April 18, 2024

Re: Bureau of Land Management Draft Programmatic Environmental Impact Statement for Utility-Scale Solar Energy Development (89 Fed. Reg. 3687)

Figure 2. BLM's Solar PEIS Alternatives 3 and 5 would make BLM land along key Deschutes River tributaries including Trout Creek, Oregon available for solar application.

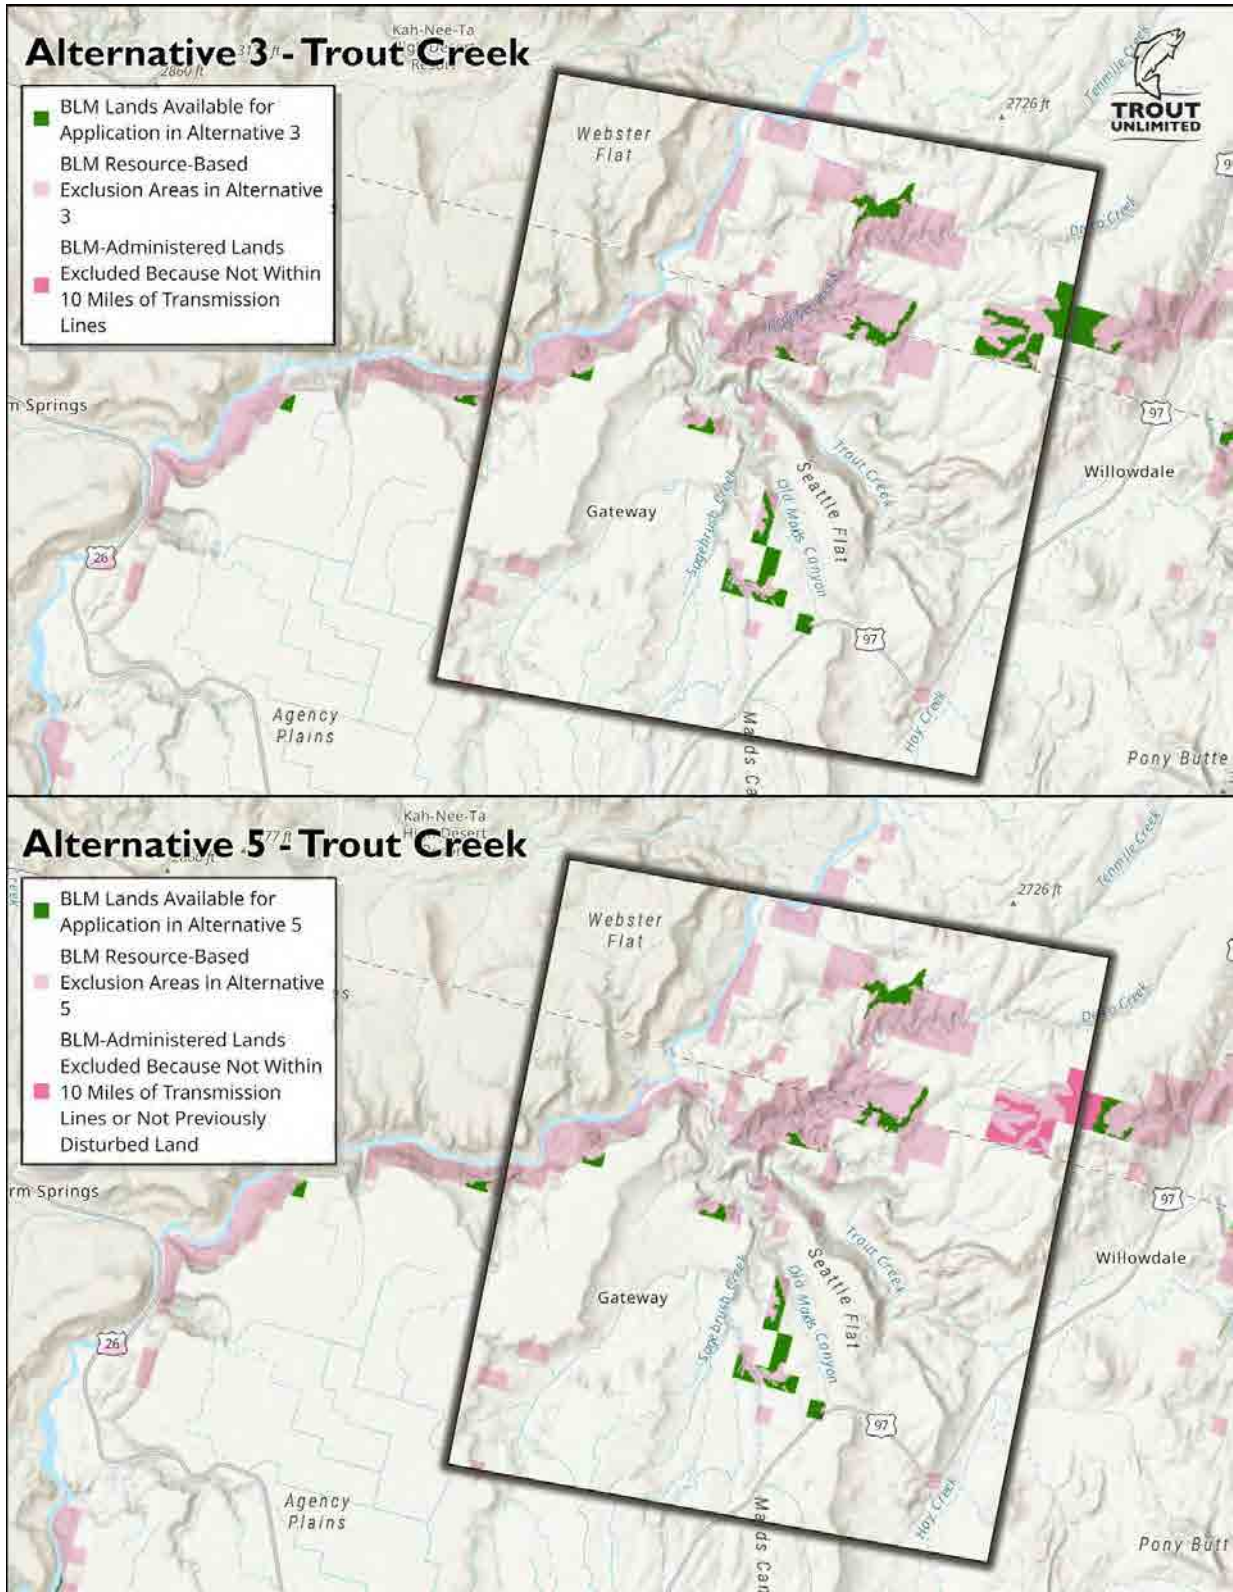
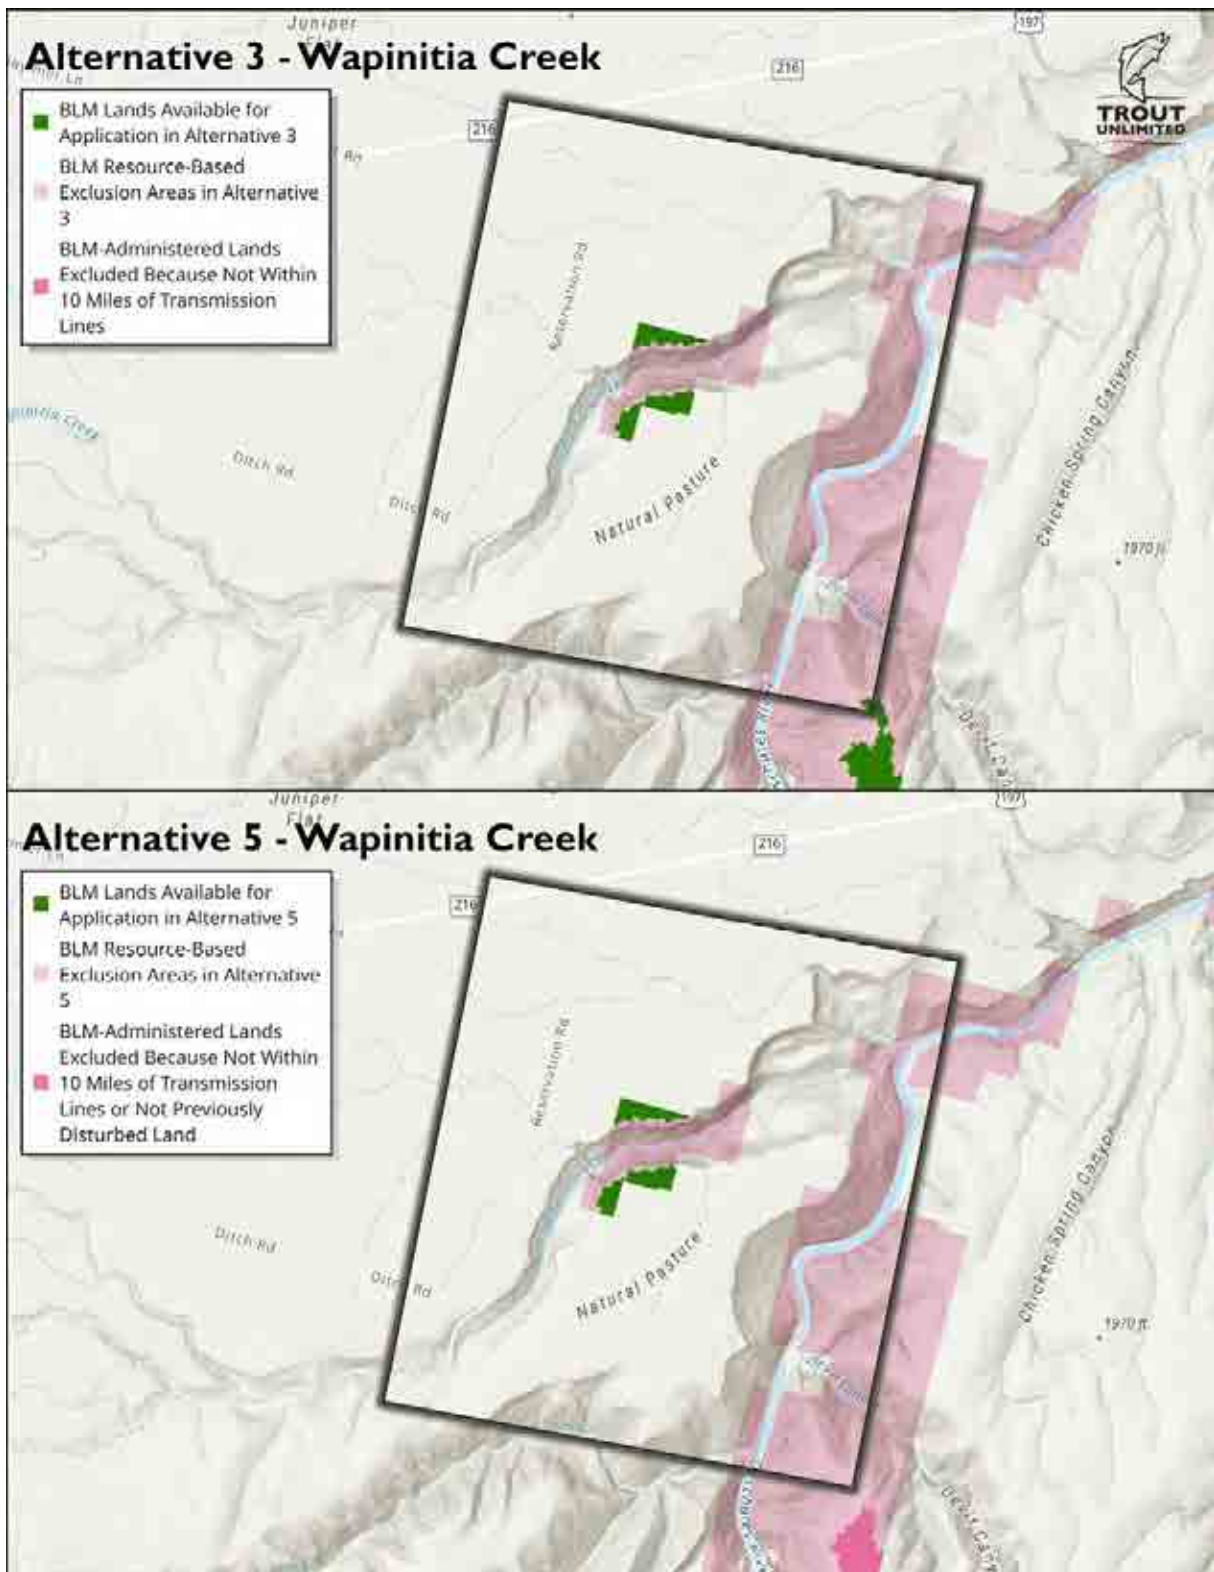
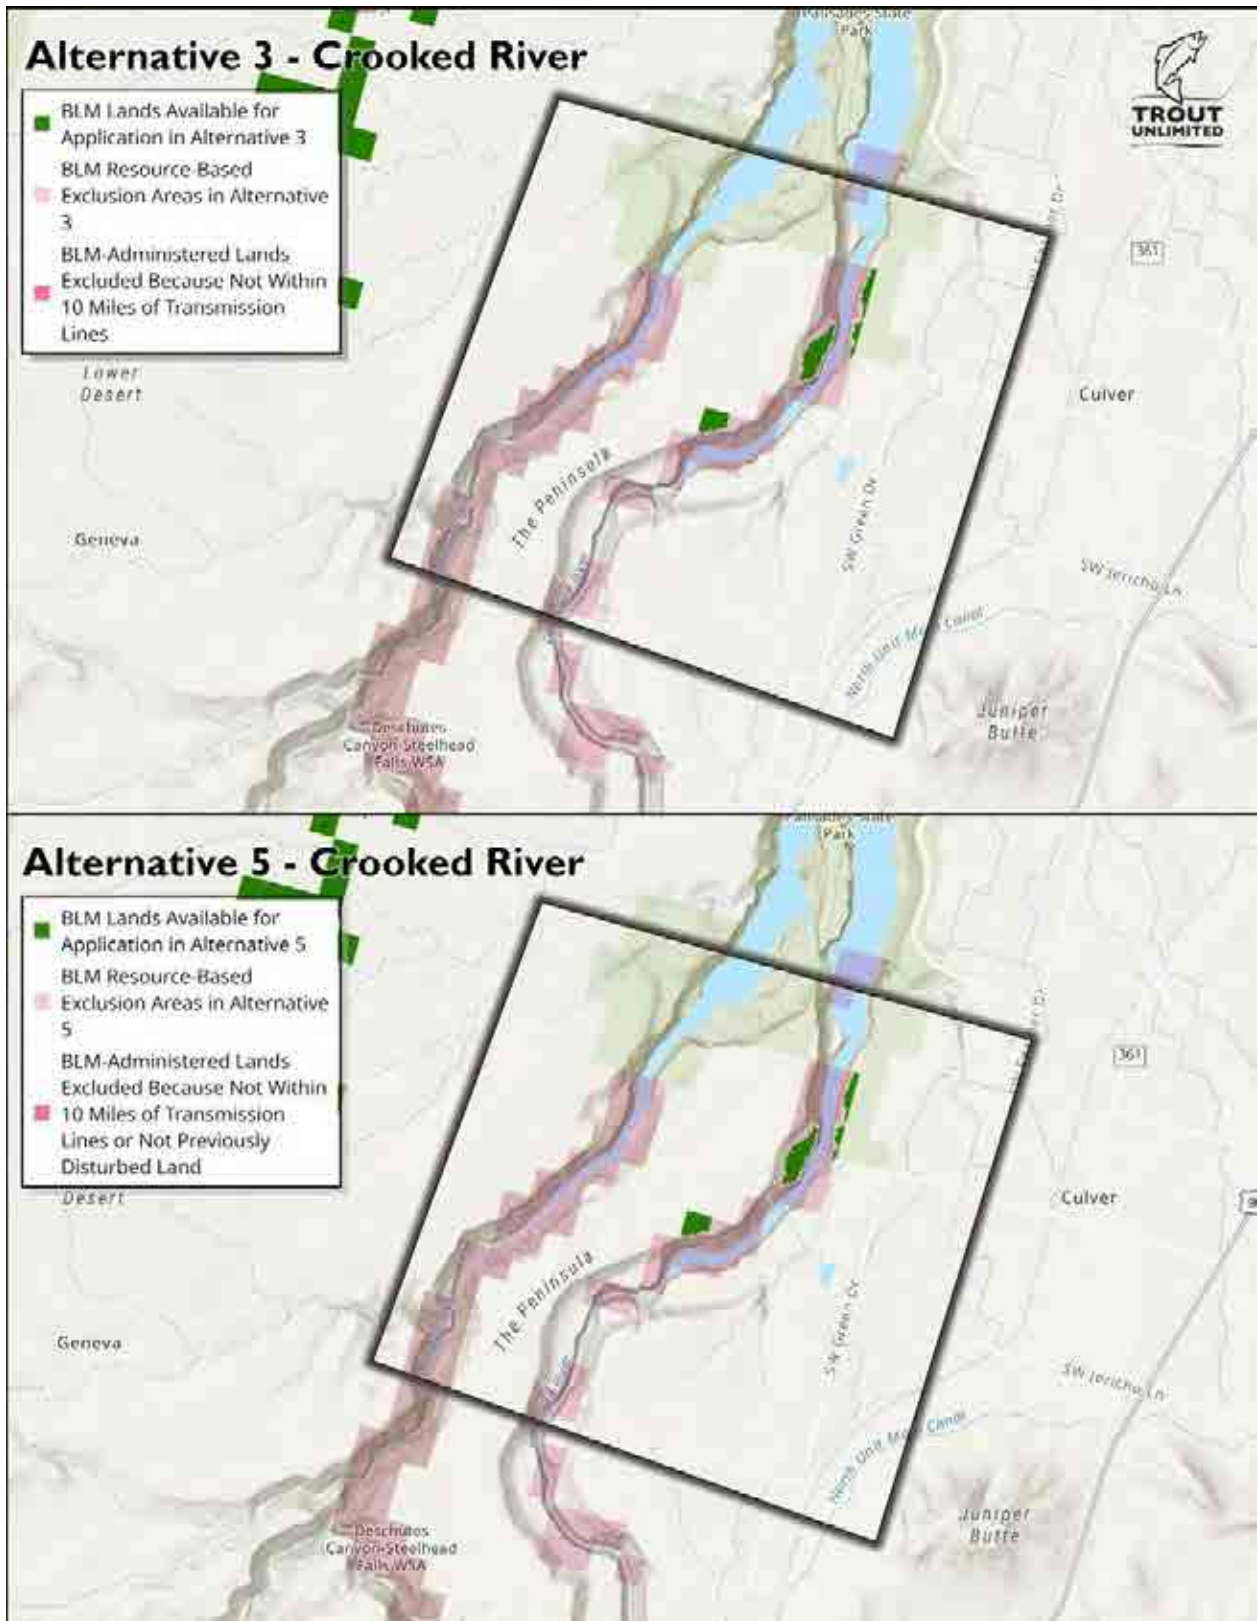
Trout Creek is a vital tributary of the Deschutes River and is designated critical habitat for Deschutes wild steelhead. Many of the steelhead that enter the Deschutes from the Columbia make the journey upriver to spawn in Trout Creek. Although the Deschutes is world-famous for its historically prolific runs of summer steelhead, anadromous fish returns to the basin have been low in recent years—particularly for wild summer steelhead. Water quality in the system is suffering from factors including, but not limited to, agricultural practices and tremendous growth of human population centers in Central Oregon. The effects of these issues are being compounded by drought conditions and climate change. Snowpack, streamflows, groundwater levels, and surface spring flows are all diminishing in the Basin.

Figure 5. BLMs Alternative 3 and 5 would make lands available for solar application in the Yakima River basin, Washington.

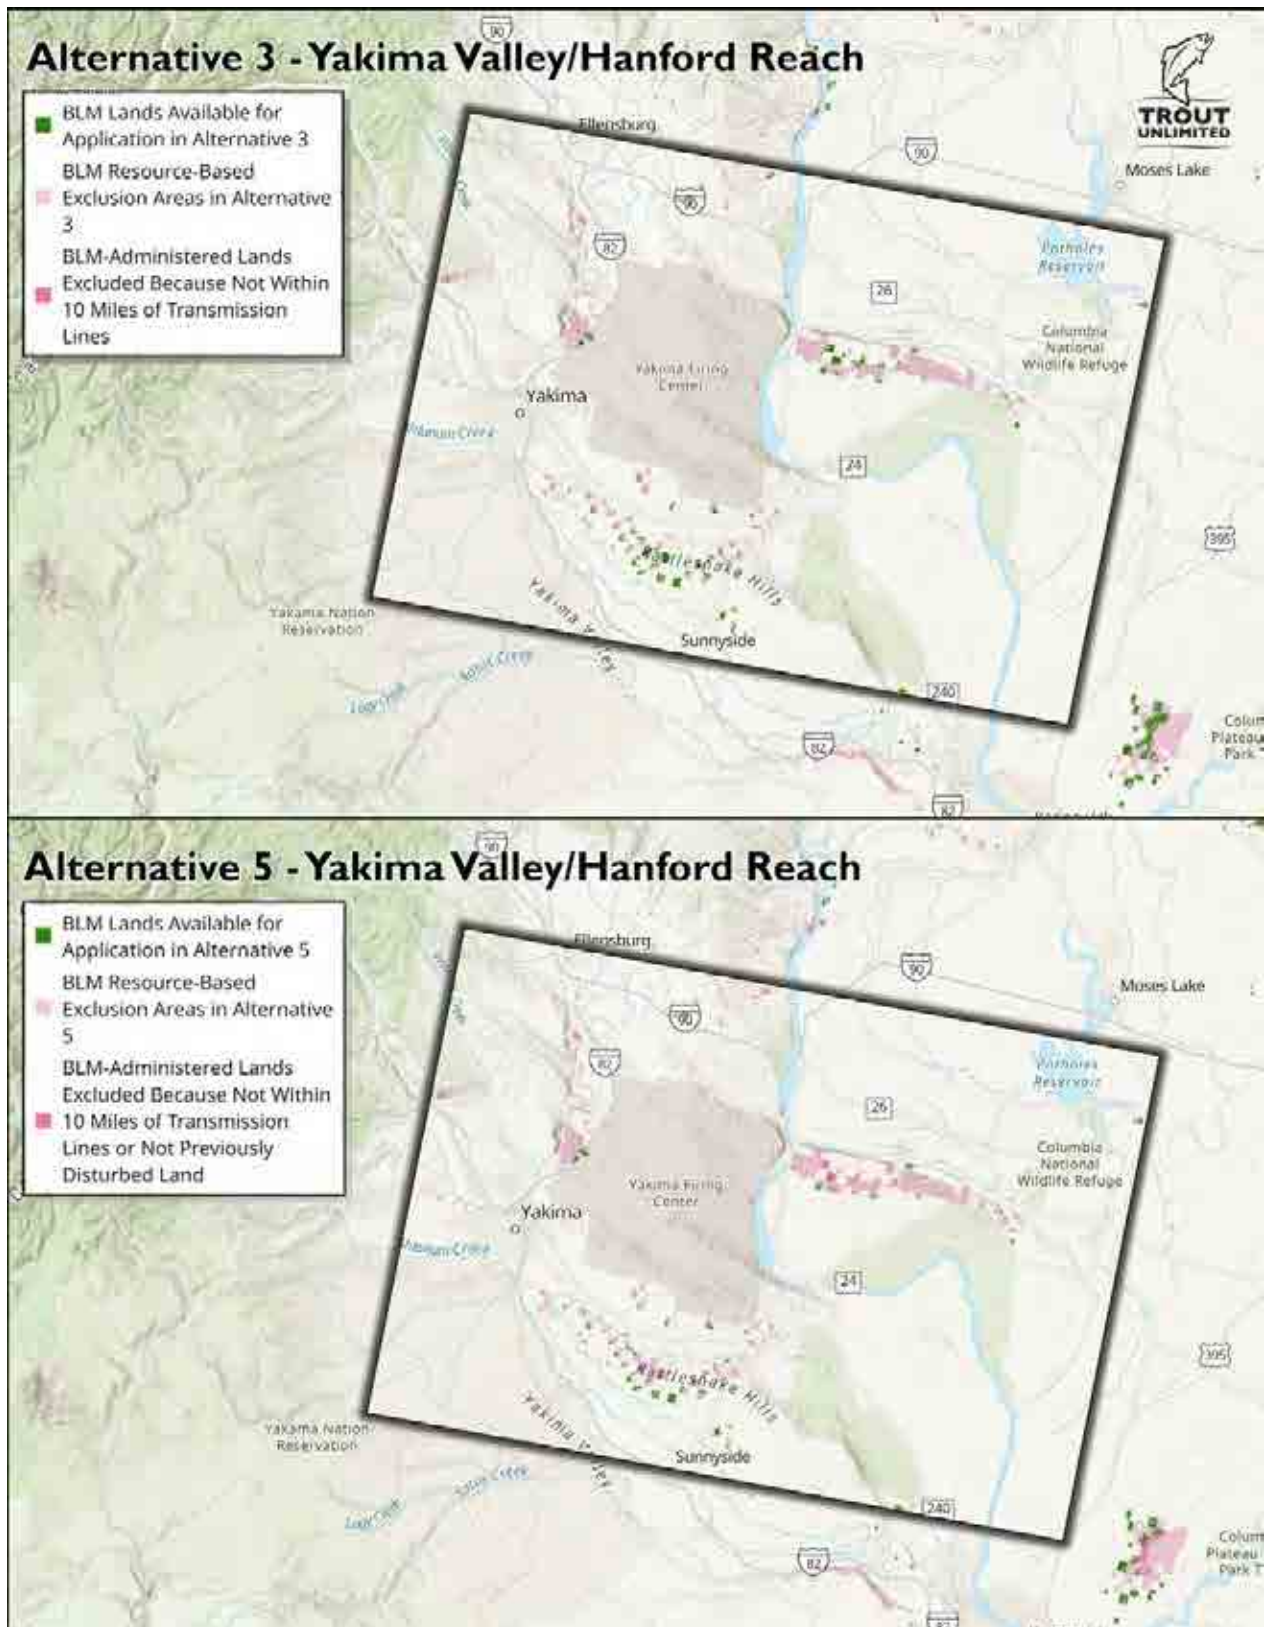
Under the Alternatives, Yakima River, Washington would be open for utility-scale solar application (Figure 5). Water is the basis of life in the Yakima Basin. Without water, there are no fish, no people, and no agriculture. The Yakima Basin’s annual water conditions are intricately tied to snowpack and runoff in Washington’s Cascade Mountains and foothills. Historically, the Yakima Basin supported a conservatively estimated 500,000-plus returning anadromous fish, including Chinook, Coho, and Sockeye Salmon, Steelhead, and Pacific Lamprey. These fish supported a robust ecosystem and are culturally significant foods for the Yakama Nation, whose ancestral home is the Yakima Basin. Ongoing fish and water conservation measures are improving conditions but current fish returns remain mere fractions of historic numbers. Despite the ongoing fish issues, the Yakima Basin represents a multi-billion dollar economy for the state of Washington. A key component of the local economy is recreation like fishing and boating in the famed Yakima River Canyon—home to one of Washington’s most accessible and scenic trout fisheries. The same canyon is home to Bighorn Sheep, elk, and Mule deer that must all quickly adapt to climate change and loss of habitat from development. The fish and wildlife of the Yakima Basin are not only integral to the ecosystem, they are vital to the ways of life in the valley.

Figure 6. BLM’s Solar PEIS Alternatives 3 and 5 would make BLM land in the Big Hole watershed, Montana available for solar application.

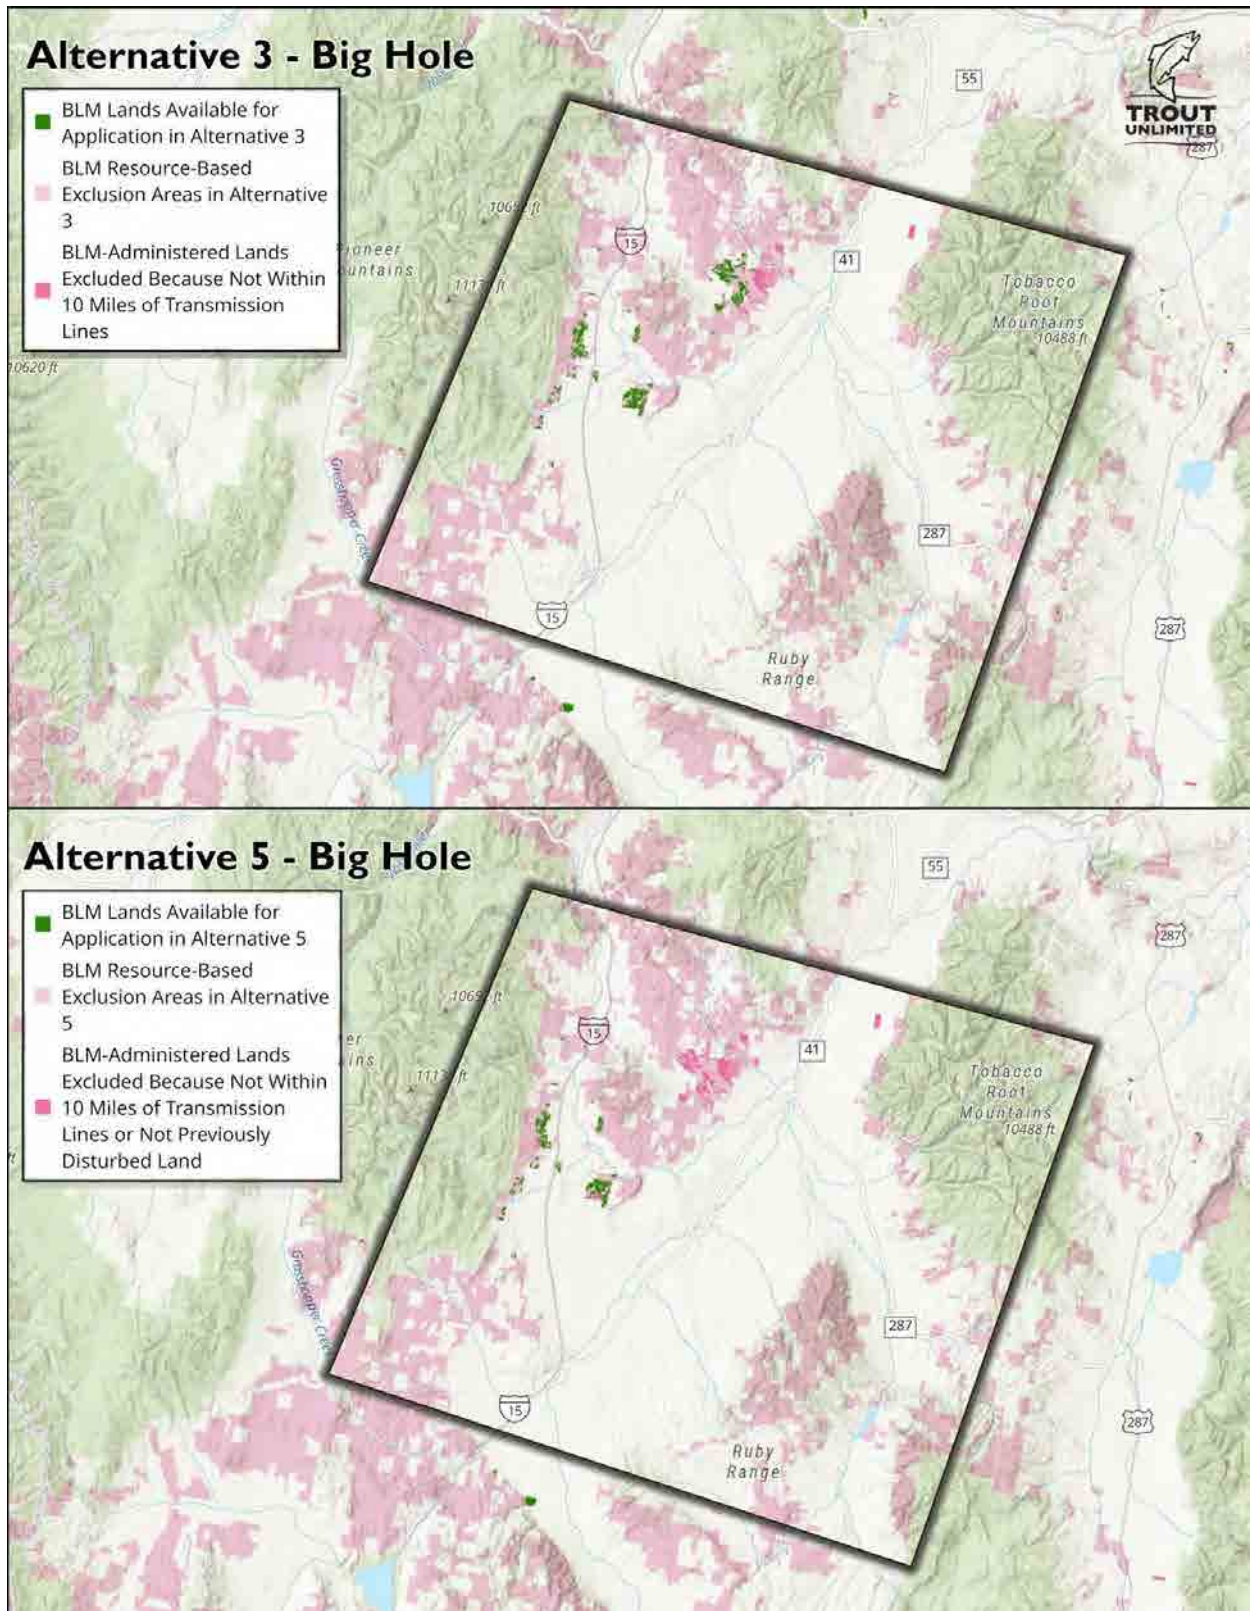
Under Alternatives 3 and 5, Big Hole watershed in Montana would have lands available for utility scale solar, north of Dillon and west of Twin Bridges (Figure 6). This area is facing constant water shortages and drought issues in the Big Hole, and the watershed is currently facing a massive decline in the Big Hole brown trout population because of lower flows and higher temps every year. While brown trout are non-native, there are native cutthroat that inhabit many of the tributaries and even the main stem in those lands deemed available. Grayling can also be found in the upper Big Hole and found further downstream on the mainstem as well. Any additional infrastructure or industrial stressor that is introduced into that region, that could have a negative impact on the watershed, should come under intense scrutiny.
